# TECHNICAL INFORMATION

59761A

**Subject** ▶ Change of Ball Bearing

**For Models** ▶ BO5010, BO5011, BO5020, BO5021

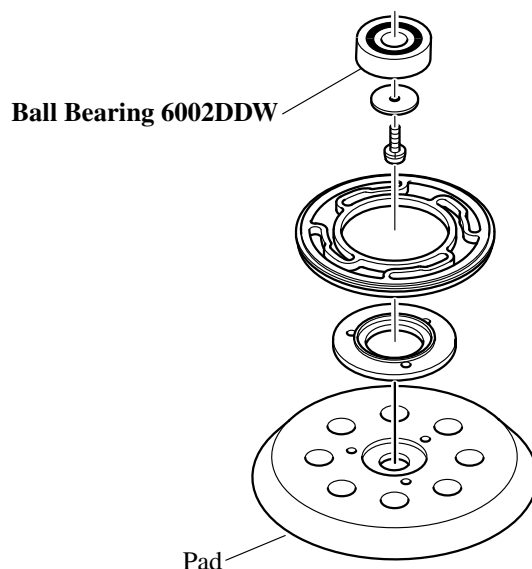
**Description** ▶ For improvement in gentle start function, the current Ball Bearing 6002DDW has been replaced by the new one in which a different kind of grease is enclosed. The new ball bearing cannot be distinguished from the current one by appearance.

| Item No.   | Current part                     |  | Q'ty | I/C | New part                         |  | Q'ty | Note |
|--|----------------------------------|--|------|-----|----------------------------------|--|------|------|
| BO5010: 020<br>BO5011: 022<br>BO5020: 031<br>BO5021: 032 | Ball Bearing 6002DDW<br>211227-9 |  | 1    | ←   | Ball Bearing 6002DDW<br>211236-8 |  | 1    |      |
